**SUSQUEHANNA STEAM ELECTRIC STATION
PROPOSED AMENDMENT NO. 280 TO UNIT 1
FACILITY OPERATING LICENSE NPF-14 AND
PROPOSED AMENDMENT NO. 249 TO UNIT 2
FACILITY OPERATING LICENSE NPF-22: REVISE
TECHNICAL SPECIFICATION 3.4.10 "RCS PRESSURE
AND TEMPERATURE (P/T) LIMITS"
PLA-5933**

**Docket Nos. 50-387
and 50-388**

UNIT 1 AND UNIT 2 CHANGES TO TECHNICAL SPECIFICATION 3.4.10

**Proposed Technical Specification Changes
(Markups)**

FIGURE 3.4.10-1
System Hydrotest Limit with Fuel in Vessel (Curve A)
for 35.7 EFY

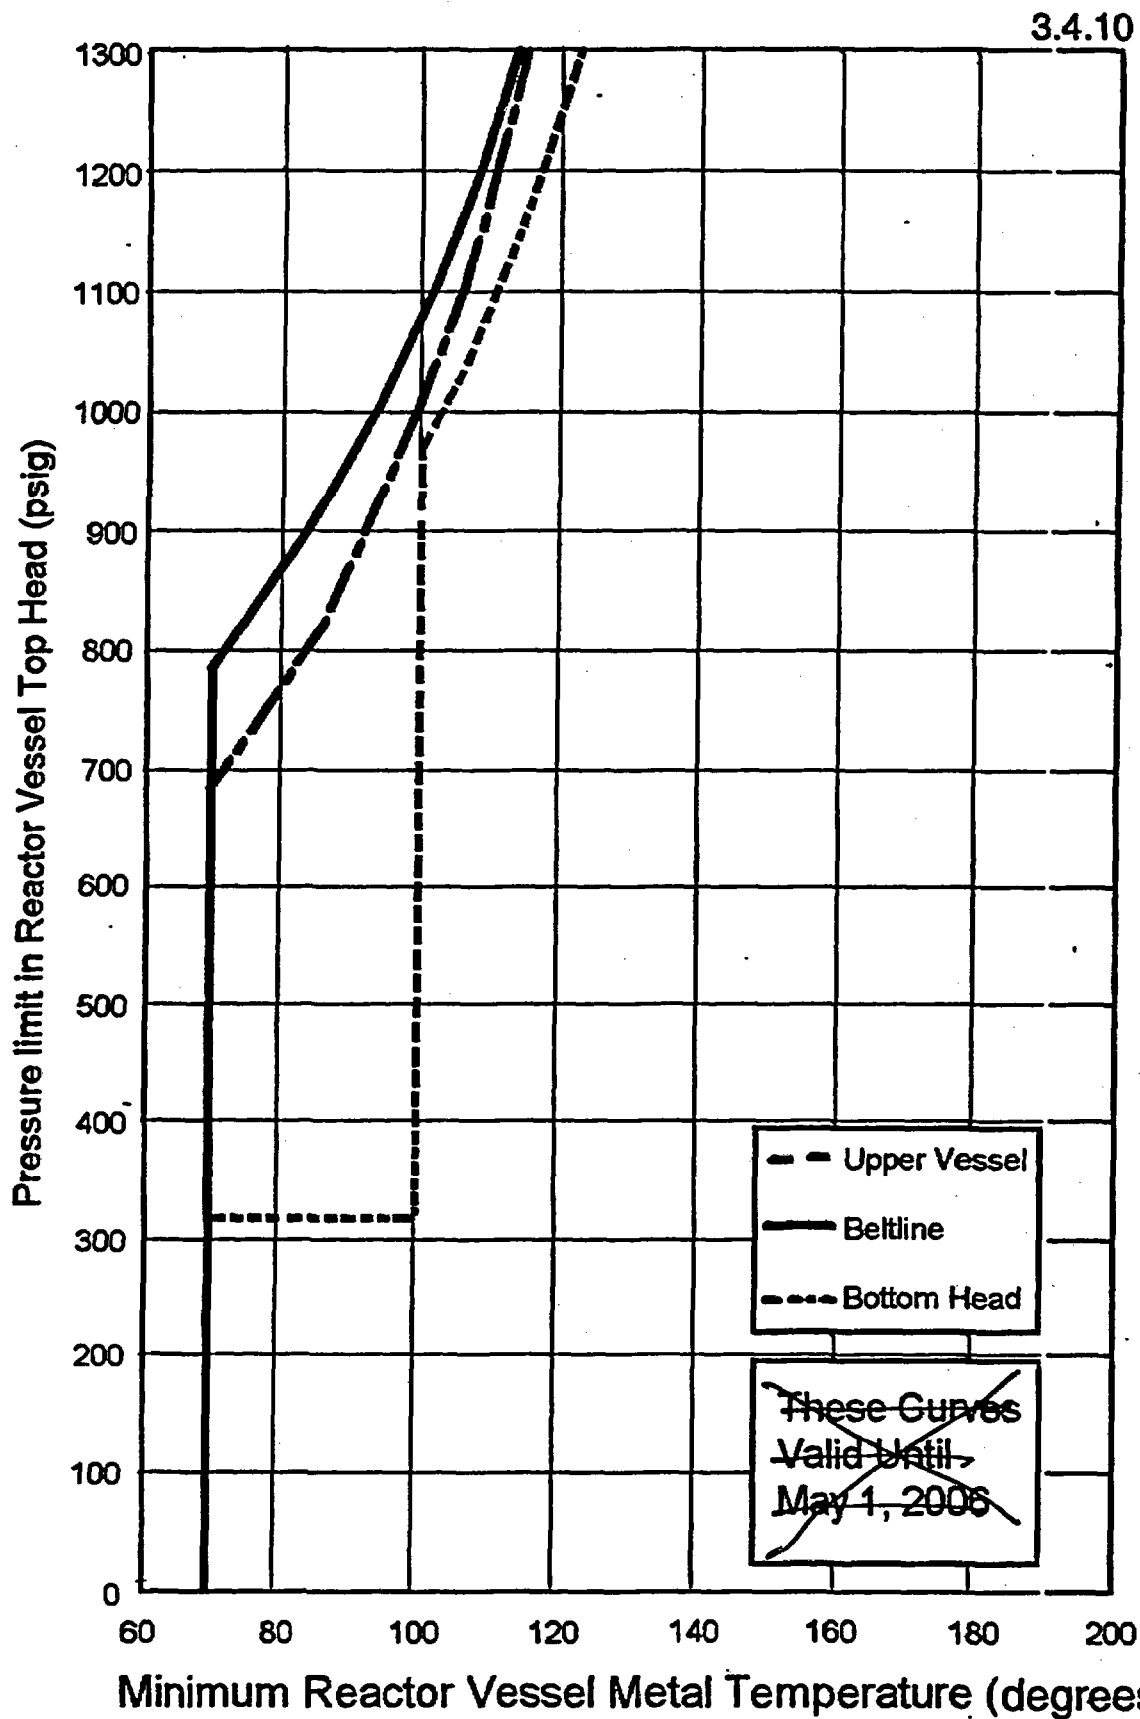
The proposed changes are to TS Figures 3.4.10-1, 3.4.10-2, and 3.4.10-3, which show the P/T limits curves for inservice leakage and hydrostatic testing, non-nuclear heatup and cooldown, and criticality, respectively.

The proposed P/T limit curves are valid for 35.7 EFPY for SSES Unit 1 and 30.2 EFPY for SSES Unit 2. The plotted values of the proposed curves have been developed to be identical to the plotted values on the present curves, contained in NRC approved Amendments 200 and 197 for Unit 1 and Unit 2 respectively. Only the limit on the validity of the curves has changed. This change in validity is due to using new BWRVIP RAMA Code (Reference 1) fluence calculation methodology recently approved by the NRC. The new fluence calculations also incorporate the proposed EPU power level of 3952 MWT.

The proposed changes revise TS Section 3.4.10, "RCS Pressure and Temperature (P/T) Limits," by removing the valid date and replacing it with the Effective Full

Power Years (EFPY) of radiation exposure limit on each of the P/T curves for SSES Units 1 and 2.
